RE: School Safety Assessment at Lawrence Elementary

School Safety Assessment Technical Memorandum

Lawrence Elementary School

Safe Routes to Schools Improvement Plan

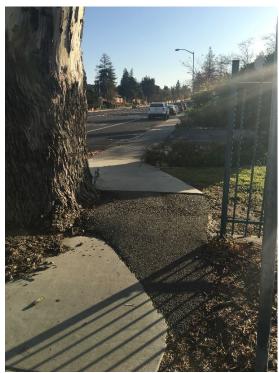
- 1. School Frontage at Portola Avenue
- Portola Avenue is an arterial road with two travel lanes in each direction and a center lane that is variably a two-way turn lane, a left turn only pocket, and a painted median. Portola has sidewalks on both sides of the street, a parking/loading zone on the school side of the street, and a Class II bicycle lane on both sides of the street. (1b; 1c)

- Conditions for people loading/unloading from vehicles, walking, and gathering at the front of the school were observed to be insufficient for the demand.

- The sidewalk in front of the school is five (5) feet wide right beside the road.
 - People were observed using the sidewalks for multiple uses such as: parents pushing strollers, students unloading from vehicles, students riding bicycles and scooters, and parents walking.

- West of the school entrance the sidewalk width was observed to be insufficient to accommodate the number of people walking.
 Additionally, car doors that open to drop-off students encroach onto the sidewalk right-of-way. (6a)

- East of the school there is a section of sidewalk less than five feet wide that is routed around a large tree and damaged by tree roots. (1a)
 - Parents were observed gathering at the plaza area surrounding the flagpole in front of the school. There was insufficient paved surface for

parents to gather while students and parents were walking from Portola Avenue to the school entrance. (6b)

- The school entrance and exit driveways create challenges for people walking, resulting in the sidewalk not crossing the driveway on a level slope. This may be challenging for people in wheelchairs or using mobility devices, parents with strollers, or students bicycling. (1d)

- The heavy flow of traffic entering and exiting the driveway made it difficult for people on foot to cross the driveways. The school principal reported that this walking route is undesirable to school staff.

- Traffic flow into and past the entrance driveway often results in conflict between different users.
 - Eastbound vehicles were observed driving to the 15-minute loading zone along Portola to the west of the school entrance to drop-off students. Vehicles then pulled back into eastbound traffic on Portola Avenue, conflicting with drivers waiting to turn into the entrance. (1f)

- O Drivers were observed driving eastbound on Portola in the rightmost travel lane and turning right into the school entrance to drop students off within the parking lot circle. These drivers were directly conflicting with drivers who dropped students off along the 15-minute loading zone and were attempting to merge back into eastbound traffic.

- Non-school related thru-traffic was observed eastbound on Portola in the leftmost lane.
 - The queue for westbound vehicles attempting to turn left into the school entrance was longer than could be accommodated with the leftturn pocket as vehicles waited for an opportunity to turn left into the school. This was due to congestion in the parking lot.

- Traffic flow out of and past the exit driveway often results in conflict between different users.
 - Drivers were observed driving to the 15-minute loading zone along Portola to the west of the school exit to drop-off students. They then pulled back into eastbound traffic on Portola Avenue.

- Drivers were observed driving out of the school drop-off loop in both the eastbound (right turn) and westbound (left turn) direction.
 Westbound drivers were often delayed in exiting due to being blocked by the long queue of vehicles in the center turn lane waiting to turn left into the school entrance. (1e)

- Signage and striping observations include: (1g; 1h; 2i)
 - Red-painted curbs before and after the driveway entrance and exit is appropriate and serves to adequately "daylight" these access points.

- The sloped pavement across the driveway entrance and exit is painted yellow. It is not clear if this is intended to be a crosswalk or to highlight the slope for people driving. This is not MUTCD-compliant.

- There are no school pavement markings (CA-MUTCD 3B.20) on Portola Avenue in either direction.

- There is one speed limit sign and speed radar feedback sign in the eastbound direction on Portola Avenue. These signs are located next to the school entrance driveway.
- There are no speed limit signs or speed radar feedback signs in the westbound direction on Portola Avenue.
- A school Assembly D sign is located ahead of the school exit in the eastbound direction and obscured by tree branches.

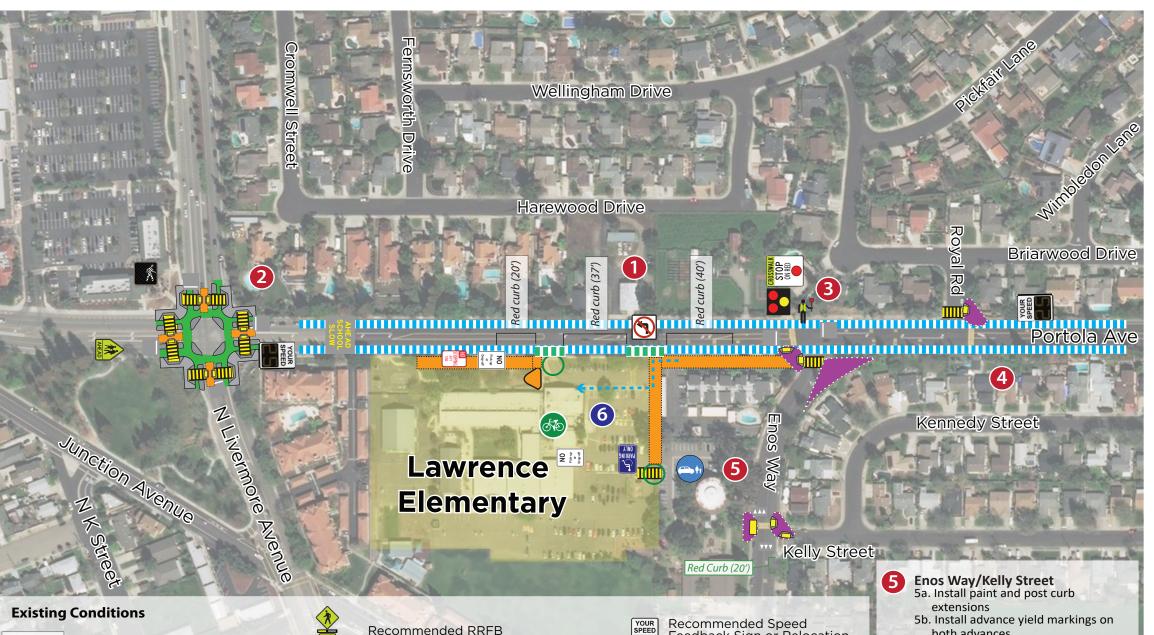
- 6a. Widen sidewalk to west of school driveways to create more space for people to walk. Short Term: Create widened path using decomposed granite. Long Term: Widen concrete sidewalk
- 6b. Widen plaza area in front of school 6c. Install high-visibility crosswalk from church parking lot to school playground entrance
- 6d. Widen existing sidewalk on eastern edge of parking lot, and pave sidewalk where it does not exist
- 6e. Relocate R99 Disabled Parking Only sign to northern side of crosswalk and install disabled parking markings
- 6f. Install "No Pick-up or Drop-off" signage on eastern side of school
- 6g. Establish church parking lot as Park & Walk location

- 1a. Repair and widen sidewalk to east of school driveways
- 1b. Upgrade the existing Class II Bicycle Lanes on either side of the street to Class IV Separated Bikeway Note: This recommendation would require a road diet on Portola

- Avenue and is not included as a recommendation in Livermore's 2018 Bicycle, Pedestrian, & Trails Active Transportation Plan (ATP) 1c. Reconstruct ADA-compliant sidewalk across driveway entrance and

- exit, and remove existing yellow markings. Consider adding green bicycle zone conflict markings at driveways
- 1d. Restrict left turns out of driveway exit during drop-off and pick-up 1e. Add "No Stopping During School Pick-up and Drop-off" signage and "No Pick-up or Drop-off" signage to school frontage ahead of

- driveway entrance 1f. Evaluate and consider relocating speed limit sign(s) and radar feedback sign location (signs for east bound Portola between N Livermore Avenue and Royal Way) to provide motorist more advance notice of the school zone

- 1g. Install yellow "SLOW SCHOOL AHEAD" pavement markings

- 2a. Immediately remove pedestrian actuation buttons from medians due to lack of pedestrian refuge islands in current intersection configuration
- 2b. Install pedestrian refuge islands and reinstall pedestrian actuation

- 2c. Study feasiblity of signal timing update to include a leading pedestrian interval. If warranted, upgrade existing pedestrian signalheads to include countdowns

- 2d. Install curb extensions at all four corners to shorten turning radius
- 2e. Install or consider installing protected intersection bicycle treatments at all four corners. Note: This recommendation is not consistent with recommendations in Livermore's 2018 ATP

- 2f. Upgrade existing transverse crosswalks to yellow high-visibility crosswalks across all approaches
- 2g. Install advance limit lines across all approaches

- 2h. Install green bicycle zone conflict markings across the intersection at all four approaches
- 2i. Relocate existing School Assembly D sign

- 3a. Explore if this location meets warrants for the installation of a pedestrian hybrid beacon. If warranted, install advance stop markings at both approaches
- 3b. If pedestrian hybrid is not warranted, install advance yield markings
- 3c. Restripe and straighten existing high-visibility crosswalk
- 3d. Install curb extension at southwest corner. Build with paint and posts in the short-term and upgrade to concrete when funding becomes available. Ensure design accomodates recommended Class IV Separated Bikeway
- 3e. Reconfigure southeast corner to tighten corner geometry and shorten cross distance. Build with paint and posts in the short-term and upgrade to concrete when funding becomes available

- 4a. Remove existing high-visibility crosswalk to encourage families to cross at Enos Way
- 4b. Install curb extension at northeast corner. Build with paint and posts in the short-term and upgrade to concrete when funding becomes available. Ensure design accomodates recommended Class IV Separated Bikeway
- 4c. Install high-visibility crosswalk across northern approach
